REPORT
ON
PROJECT
OF THE
United Comstock Pumping Association
FOR
Unwatering the North Comstock Mines
—
ANSWERING FORTY-SEVEN QUESTIONS
OF
MR. WHITMAN SYMMES

October 29, 1913

REPORT ON PROJECT OF THE UNITED COMSTOCK
PUMPING ASSOCIATION FOR UNWATERING THE
2700 LEVEL OF THE NORTH COMSTOCK MINES,
ANSWERING FORTY-SEVEN QUESTIONS OF WHIT-
MAN SYMMES, SUPERINTENDENT OF THE MEXI-
CAN MINE.

Diagram 1

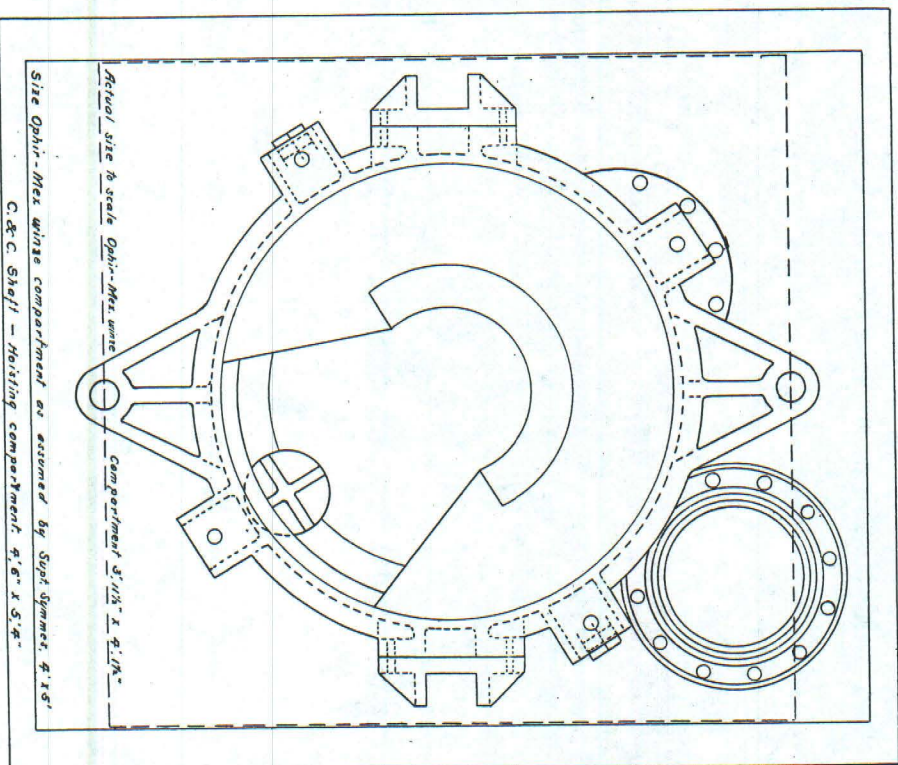
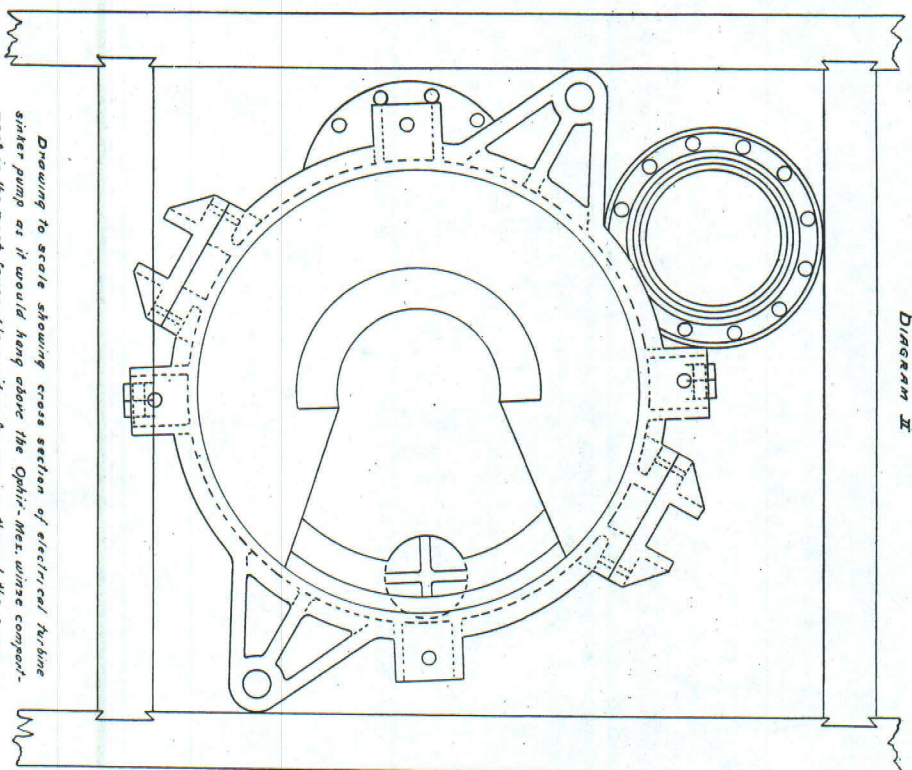
The fourth factor is one which will greatly astonish you, as it involves an error in observation of the grossest kind on the part of my predecessor in the management here, which has already occasioned heavy losses and might have caused further loss of time and money had the former plans for unwatering the 2700 level been adopted by me. This factor is the smallness of the compartments of the Ophir-Mexican winze, which are of a size utterly precluding the passage of the electrical turbine sinkers through them.

On assuming the management I found, among the papers of the Pumping Association, a drawing of the Ophir-Mexican winze compartment, which shows it to be four feet wide and five feet long. Compartments of this size might, theoretically, permit the passage of the electrical sinker, though actually there would be serious difficulties involved in the operation.

However, a careful examination of the winze disclosed the fact that its compartments are really but 3 feet $11\frac{1}{2}$ inches wide by 4 feet $1\frac{1}{2}$ inches long, a circumstance accounted for by Mr. McCormick as follows: In former times each mine made its own ore cars from designs more or less dependent upon the caprices of the various superintendents. In this way it chanced that Con-Virginia used rather large cars, which resulted in winze compartments in that mine of a size, 4 feet 4 inches by 4 feet 7 inches, while Ophir on the other hand, had only small cars, for the passage of which smaller winze compartments were adequate. When you made your plans for using the electrical sinkers in the Ophir-Mexican winze, it appears that you must have deceived yourself by a failure to sound and plumb the winze beneath the water level at its collar. If you should now care to do this you will find that the compartments really measure 3 feet $11\frac{1}{2}$ inches by 4 feet $1\frac{1}{2}$ inches as I have stated, except in the first four feet below the winze collar, where the timbers are widened out to allow room for the installation of chairs for the cage.

1st Outer rectangle (4'8" x 5'6") as pump hangs in C.&C. shaft compartment through which it was lowered and raised with difficulty due to swinging of pump and binding of rods against timbers.
2nd Middle rectangle (4' x 5'), actually fictitious diagram showing Ophir-Mex. compartment as erroneously portrayed in U.S.R.R. drawing left among records of Mr. Symmes' administration.
3rd Inner rectangle (3'11" x 4'1") actual size Ophir-Mex winze compartment through which pump could not possibly pass.

first lowered one of the turbine sinkers through the C. & C. Shaft, the operation required eight hours. When I, myself, have either lowered or raised one, I have found it a dangerous and tedious task because of the tendency of the pump to swing and bind itself against the timbers, so that it had to be repeatedly pried out again with crowbars; and I have become convinced that the C. & C. Shaft compartments though 4 feet 6 inches by 5 feet 4 inches are none too roomy for the passage of these pumps and about as small as they should be. (See Diagram I.)

Had the Ophir-Mexican Winze compartments been four feet by five feet as shown by diagram left by you in the office records, it would even then have been almost a hopeless task to pass the pumps through them. But as the compartments actually are, this would be entirely out of the question. If the pumps were hung above them as they were intended to be hung they would protrude about 6 inches into the timbers.

Drawing to scale showing cross section of electrical turbine sinter pump as it would hang above the Ophir-Mex. winze compartment in the most favorable position for passing through the same. If said pump, weighing $6\frac{1}{2}$ tons, could be lowered and operated without guides, freely suspended on a cable, and could be conceived to require no clearance whatever within the timbers, even under such a purely theoretical assumption, it would still protrude $2\frac{1}{2}$ inches into the timbers.
